## Release Note. (CP4 3.5.0)

**H/W** : CP4, CP4S

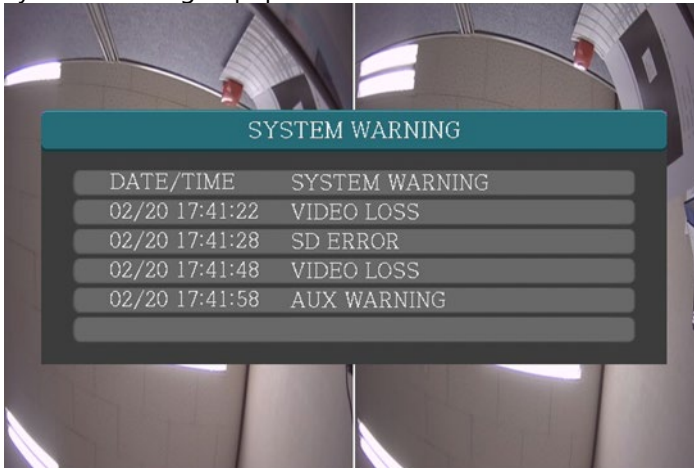
- 15) PANIC event is available on menu and popup screen.

PANIC event is activated when pressing the button more than 1 second.

- xi. Available on Event Menu

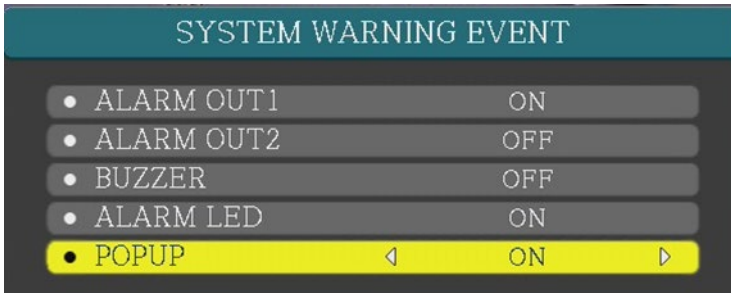
- 25) CarPulse speed can be saved at 2Hz or 0.1Km/H unit on DRV file.
- 26) Operation Specification is changed on System Warning
  - i. A function to pop up a window to display time and event of system warning

- ii. 5 warning events are displayed. (First one deleted when 6th comes.)
  - iii. Upper is older on list.
  - iv. System Warning icon() is added.
    - The icon is displayed on top left corner of live screen.

- Duration is initialized when another event is occurred within the duration.
- The list is initialized after the duration.
- vi. Pop-up window and warning list are initialized when pressing ESC button.
- vii. Pop-up window is not removed even the warning event is recovered.
- viii. Warning is displayed again when the event is occurred again from recovery.
- ix. System warning pop-up windows is only available on Live screen.
  - It is not available on Playback, Menu, another pop-up window on Live.
  - In the above condition, pop-up window is not displayed and event is not recorded, neither.
- x. System Warning Popup Windows

- xii. Configuration Tool

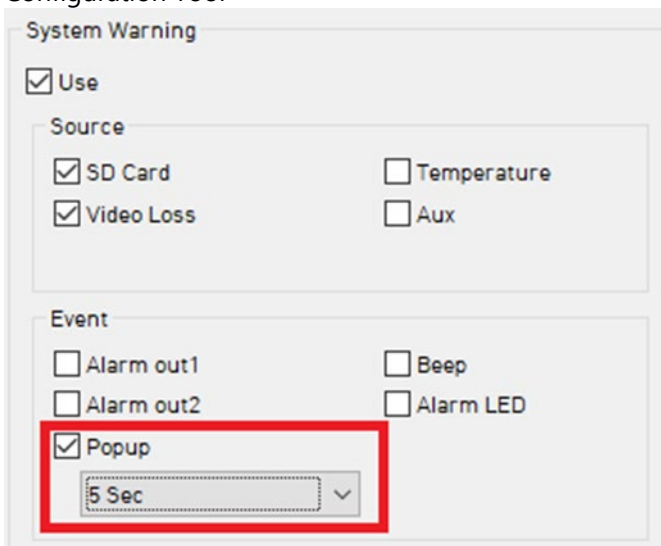
- The icon is synchronized with Alarm LED.
  - v. Duration can be set up for pop-up window
    - OFF, 5SEC, 10SEC, 30SEC, 1MIN, 5MIN, 10MIN, 30MIN, 1HOUR, INFINITE

- Pop-up window is displayed for set up duration.

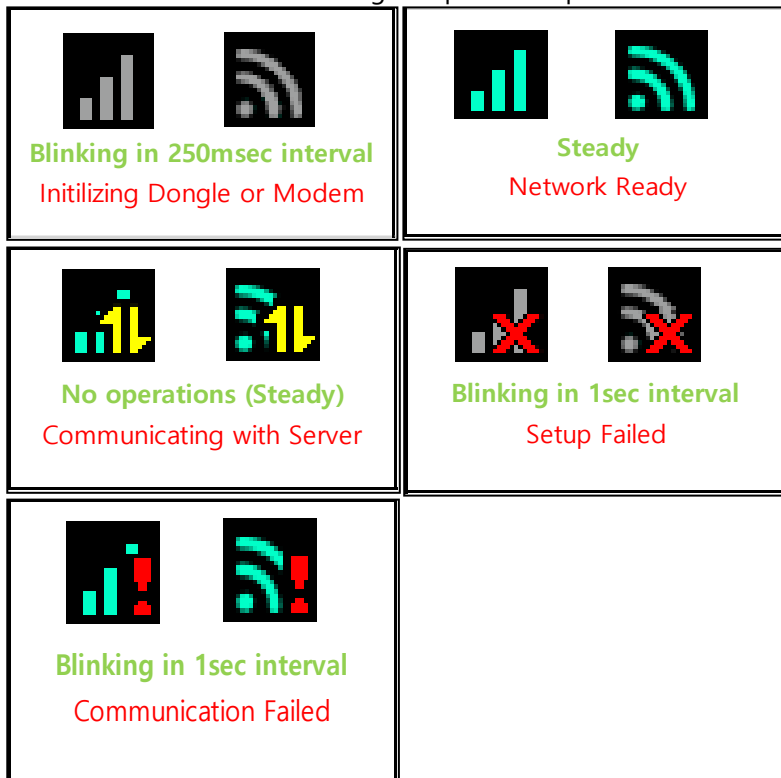
- 1) Network Status Icon and LED signal operation updated
